CITY OF CODY  
PLANNING, ZONING AND ADJUSTMENT BOARD  
TUESDAY, JUNE 11, 2013  
CITY HALL COUNCIL CHAMBERS @ 12:00 NOON

<b>MEETING DATE:</b>	JUNE 11, 2013	<b>TYPE OF ACTION NEEDED</b>	
<b>AGENDA ITEM:</b>		P&Z BOARD APPROVAL:	X
<b>SUBJECT:</b>	TEMPORARY CANOPY AT CODY COWBOY ROUNDUP, ARCHITECTURAL/SITE PLAN REVIEW SPR 2013-15	RECOMMENDATION TO COUNCIL:	
<b>PREPARED BY:</b>	TODD STOWELL, CITY PLANNER	DISCUSSION ONLY:

<b>MEETING DATE:</b>	JUNE 11, 2013	<b>TYPE OF ACTION NEEDED</b>	
<b>AGENDA ITEM:</b>		P&Z BOARD APPROVAL:	X
<b>SUBJECT:</b>	SITE PLAN REVIEW: GDA OFFICE BUILDING, SPR 2013-17	RECOMMENDATION TO COUNCIL:	
<b>PREPARED BY:</b>	TODD STOWELL, CITY PLANNER	DISCUSSION ONLY:

<b>MEETING DATE:</b>	JUNE 11, 2013	<b>TYPE OF ACTION NEEDED</b>	
<b>AGENDA ITEM:</b>		P&Z BOARD APPROVAL:	X
<b>SUBJECT:</b>	SITE PLAN REVIEW: GEE PROFESSIONAL OFFICE BUILDING (702 PLATINUM AVENUE), REVISED PROPOSAL FILE NO. SPR 2013-18	RECOMMENDATION TO COUNCIL:	
<b>PREPARED BY:</b>	TODD STOWELL, CITY PLANNER	DISCUSSION ONLY:

Application.

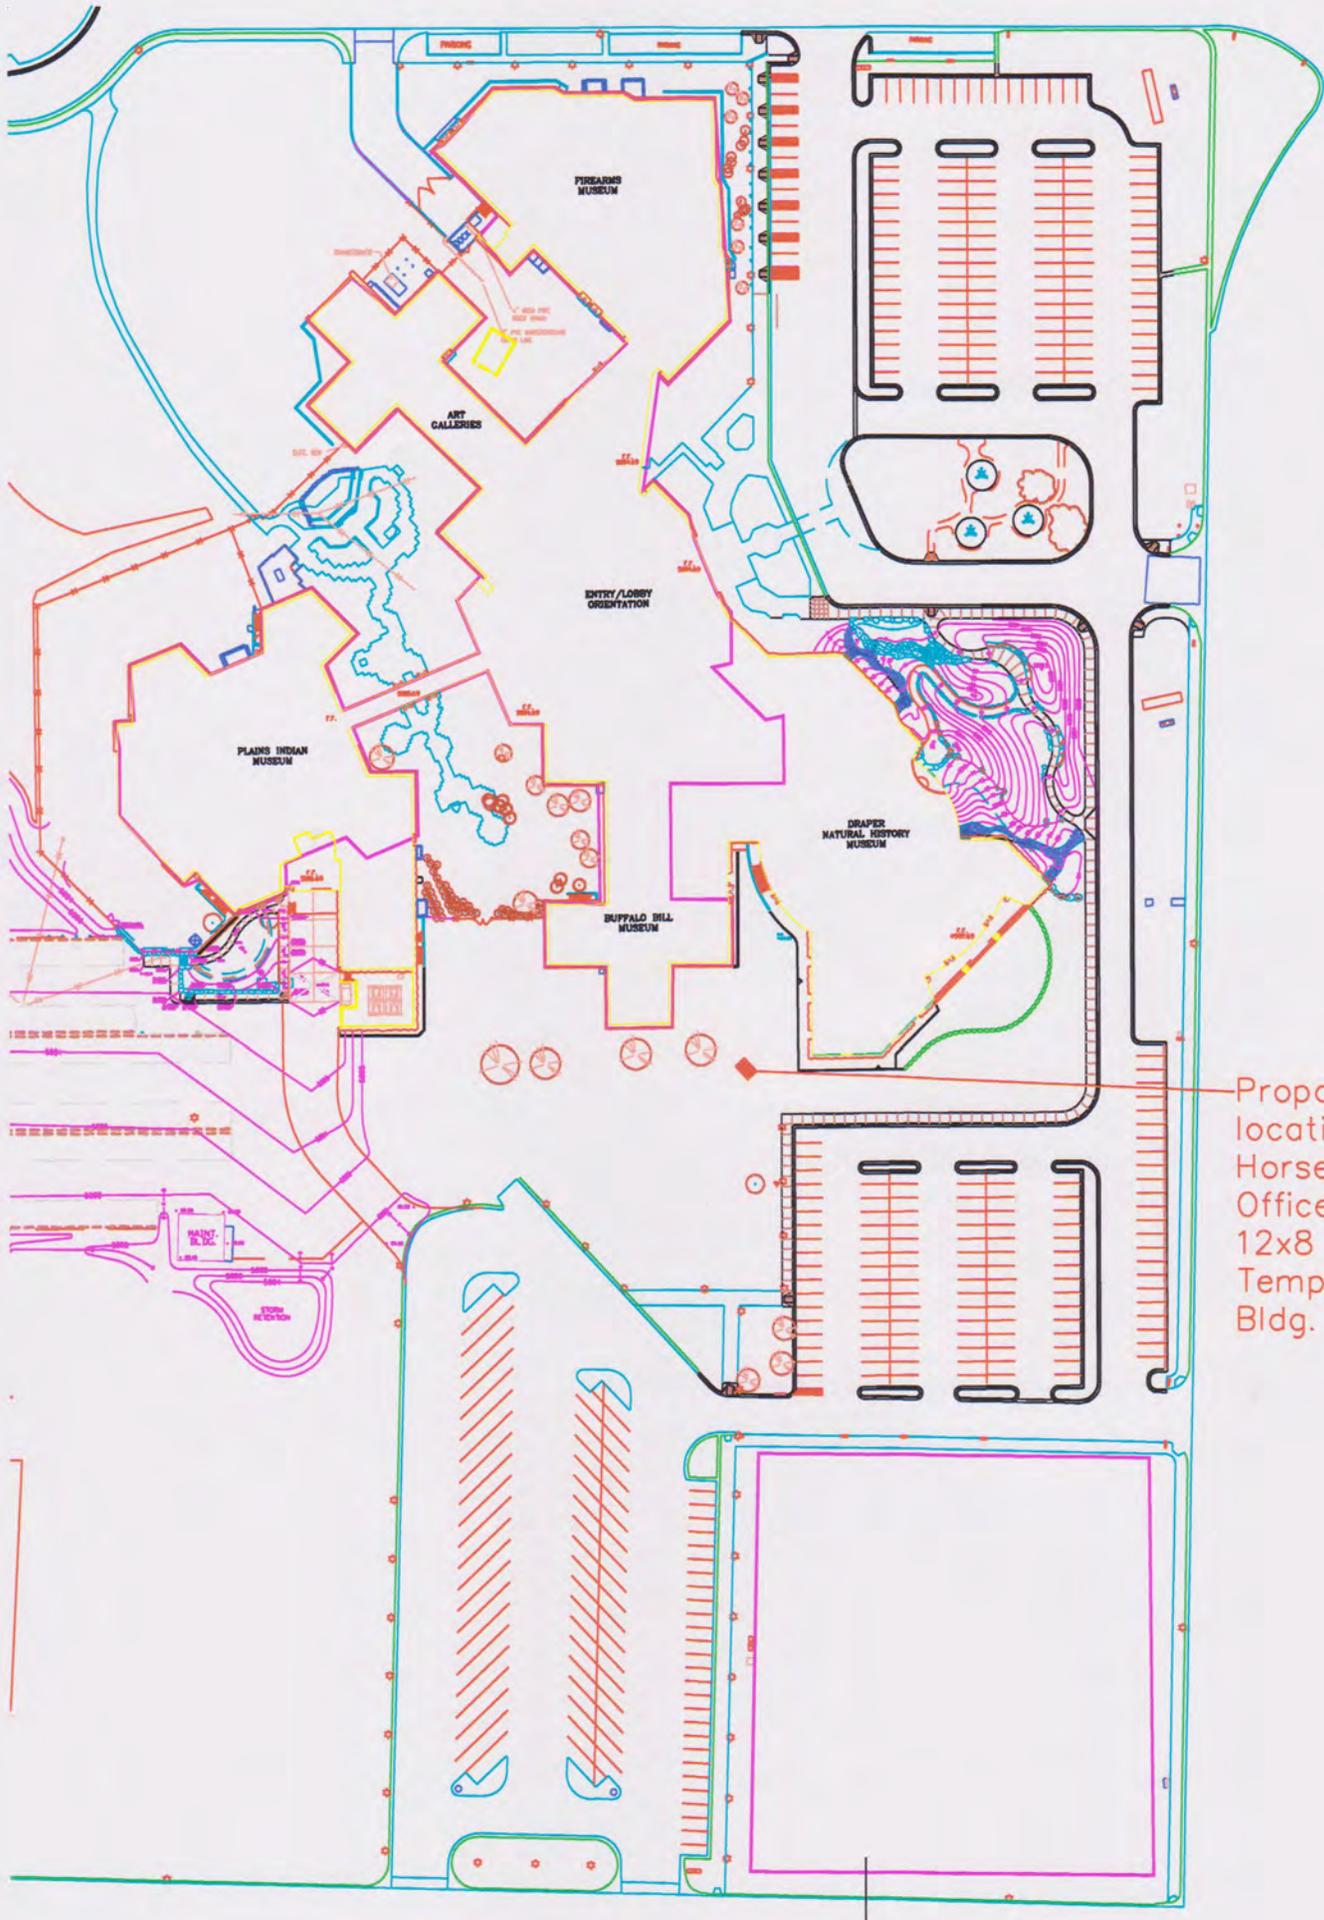
Signage for the proposal includes a temporary banner, mounted on a fence near the southeast corner of the parking lot along 8<sup>th</sup> Street. The banner must comply with the 120-day time limitation, but otherwise meets the sign ordinance (less than 32 sq. ft. and professional design). The "Horse Rides" sign on the shed is also within the size typically allowed in the D-2 zone, yet all exterior signage at the museum must be approved by the Planning and Zoning Board and they can authorize any amount of signage deemed appropriate.

1. Removing the shelter at the end of the tourist season. (Clarify intent with applicant.)
2. Obtaining a building permit as required by the Building Official.
3. Limiting use of the temporary banner as required by the sign code (120 days).

1  
C1.1  
EXISTING CONDITIONS PLAN

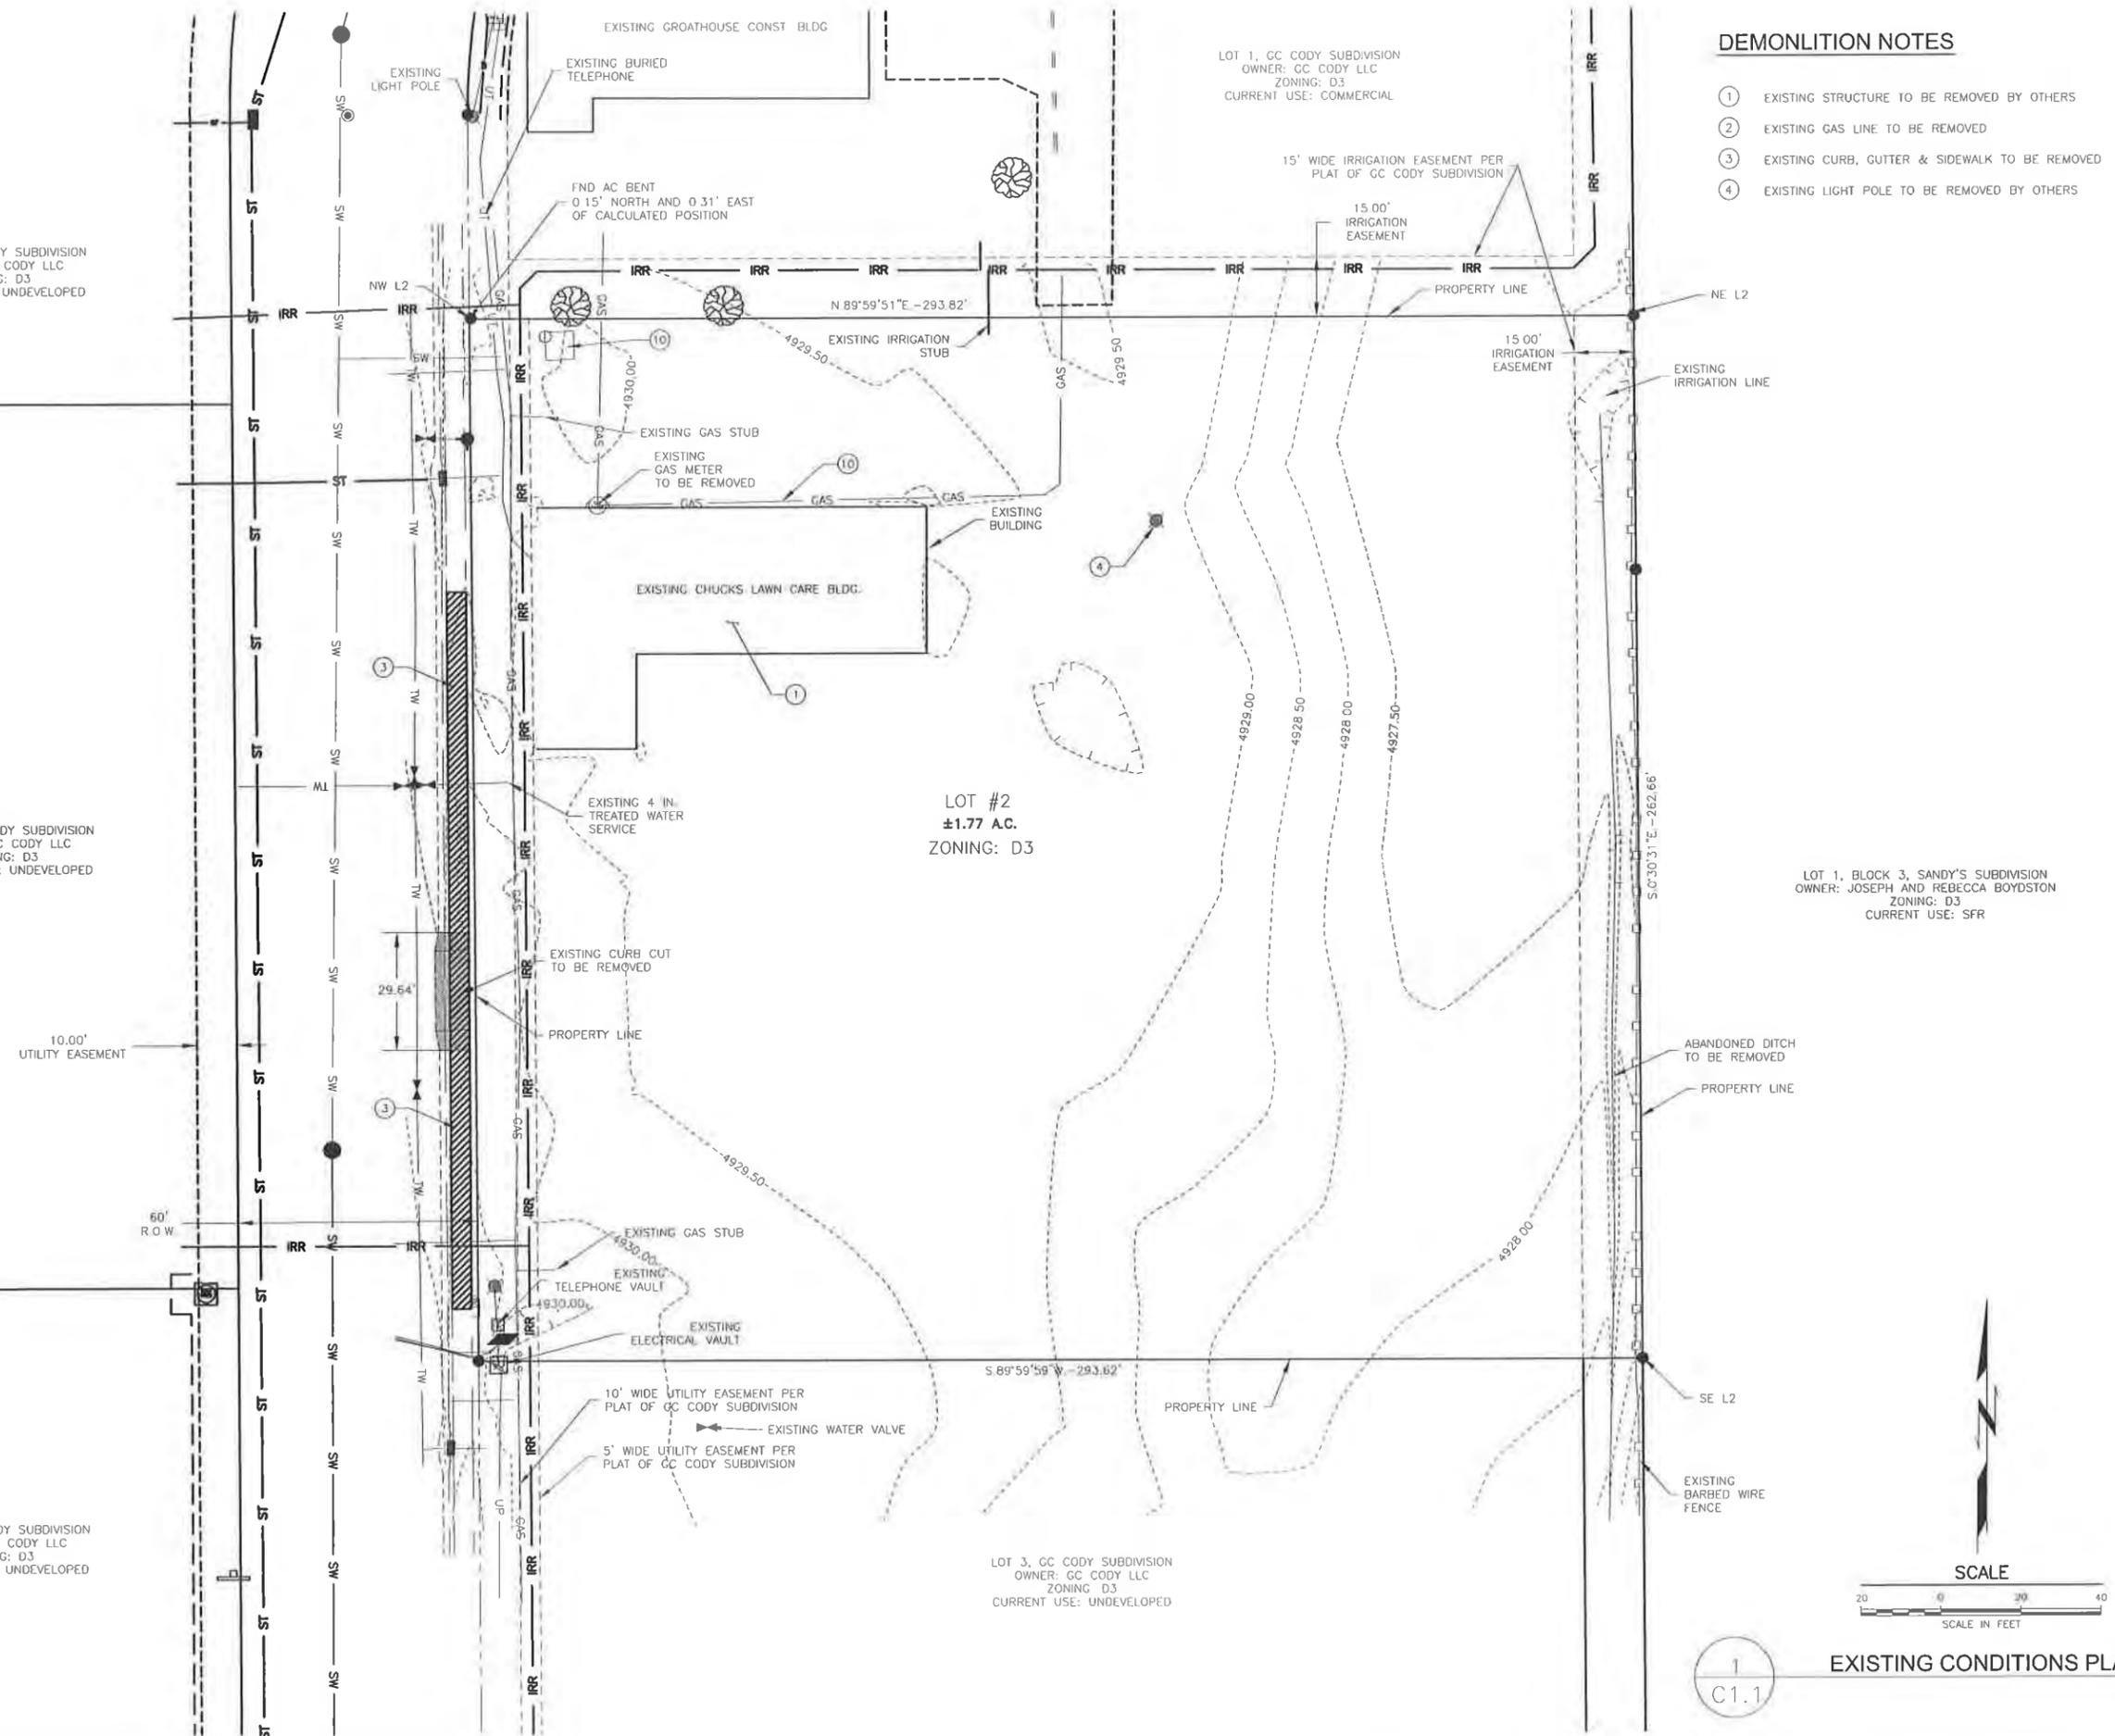
The existing shed and storage that occupy the property will be removed (currently Chuck's Lawn Care). Utilities, streets, curb and gutter, and sidewalk are provided to the property due to the past subdivision that created the lot. The demolition/existing conditions plan is shown on Sheet C1.1.

**1 C1.2** SITE PLAN

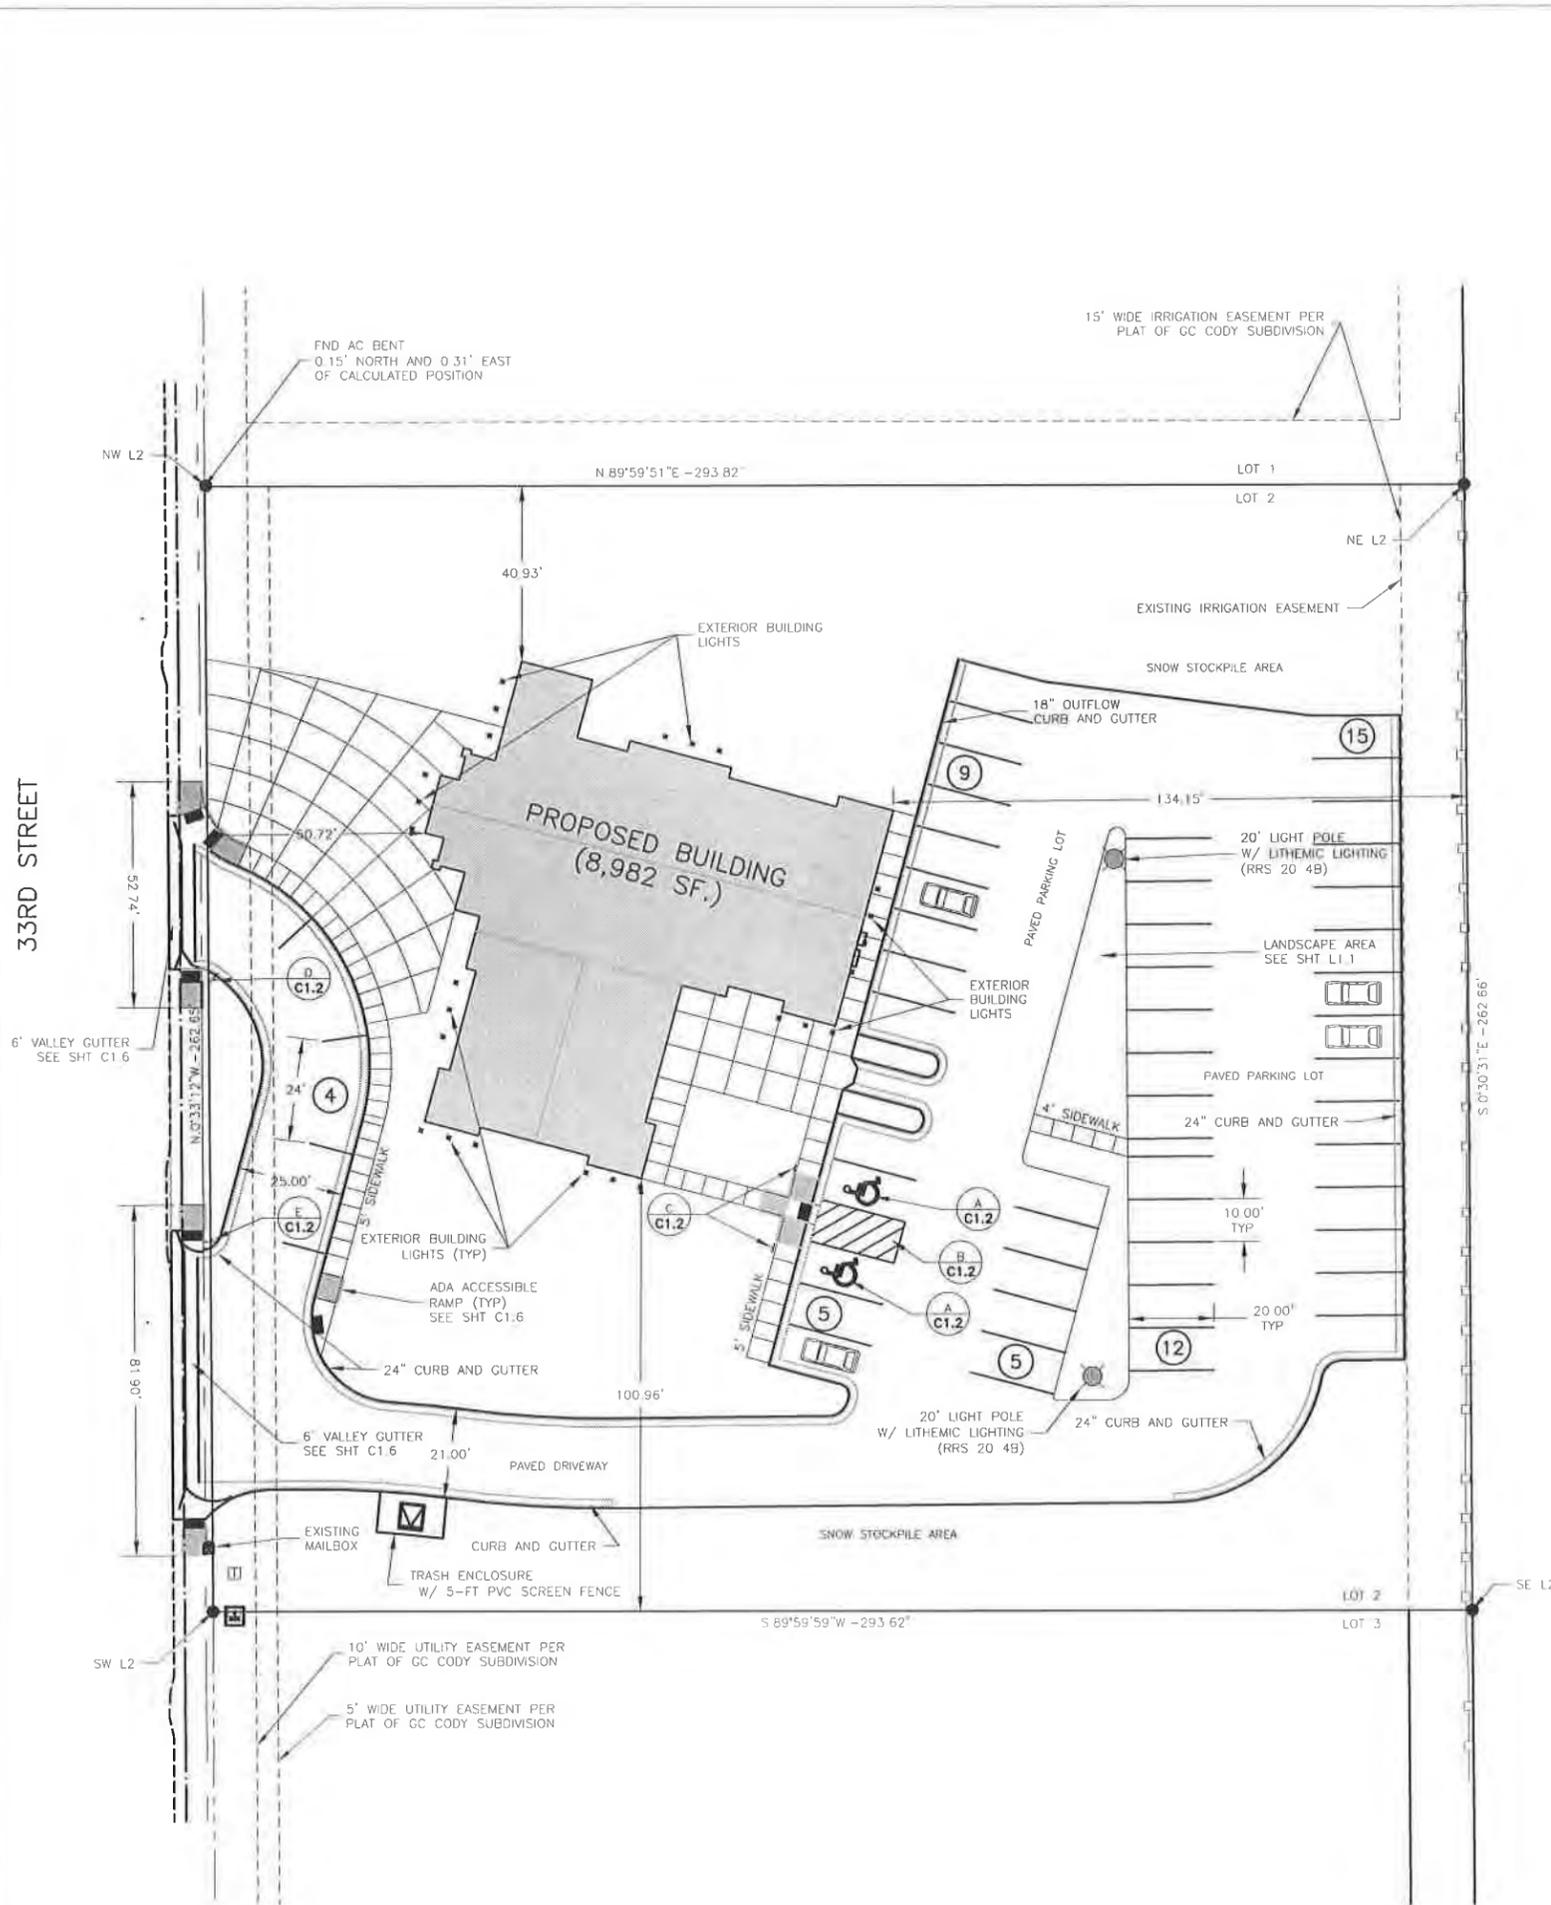
The parking ordinance requires office buildings to provide one space per 250 sq. ft. of gross floor area. The 9,726 sq. ft. building requires 39 spaces and 50 are shown. Two ADA spaces are included, as required. ADA access routes meet applicable codes.

Exterior lighting is provided by LED wall sconces, all of a down-lit style. Refer to Sheet C1.2 for locations. The light locations, heights, and throws are such that illumination beyond the property lines does not appear to be greater than about .1 to .3 foot-candles. The closest residence is of sufficient distance that it will not be significantly impacted by site lighting.

The snow storage area is shown in the landscaped area on the north side of the parking lot (see Sheet C1.2), where the snow can melt and be captured by the storm water facilities.

1. That the storm water facilities be inspected and certified by the engineer that they were completed according to approved plans, prior to building occupancy.
2. That the necessary conduits for irrigation and parking lot lighting be added to the civil plans, and installed.
3. That the appropriate label be added to Sheet C1.4 for the southernmost ADA ramp along 33<sup>rd</sup> Street (missing reference to Note 3).
4. That the project otherwise comply with the submitted site plan and applicable building, fire, and electrical codes. A building permit application is required.
